ADDRESSEES	: Owners and operators ABC Customer Care and Parts Source
VEHICLE MODEL	: AG300
MANUAL CHAPTER	: 2.30 Traction engine – exhaust system
BULLETIN TYPE	: Field Change Program
DATE	: July 7 th , 2021
SUBJECT	: To check for presence of heat insulation under exhaust-aftertreatment device
CONDITIONS	: Refer to chapter “Warranty” further on in this bulletin

DESCRIPTION:

On the above mentioned vehicles, it might be possible that heat insulation is missing in the pan under the exhaust aftertreatment device.

Figure 5

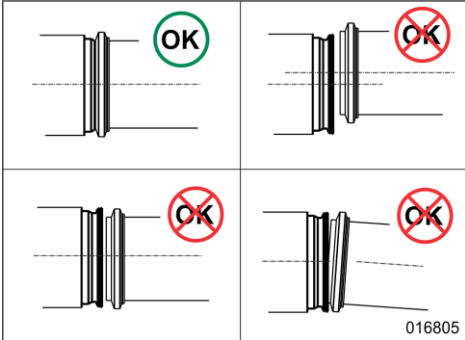
Step	Action
4.1	Clean and degrease the inside of the pan.
4.2	Stick insulation layer 11735160 (1) and insulation layers 11735477 (2) from the kit in the pan. Lay the insulation as flat as possible to avoid bunching up. <div style="text-align: right;">  <p>018044</p> </div>
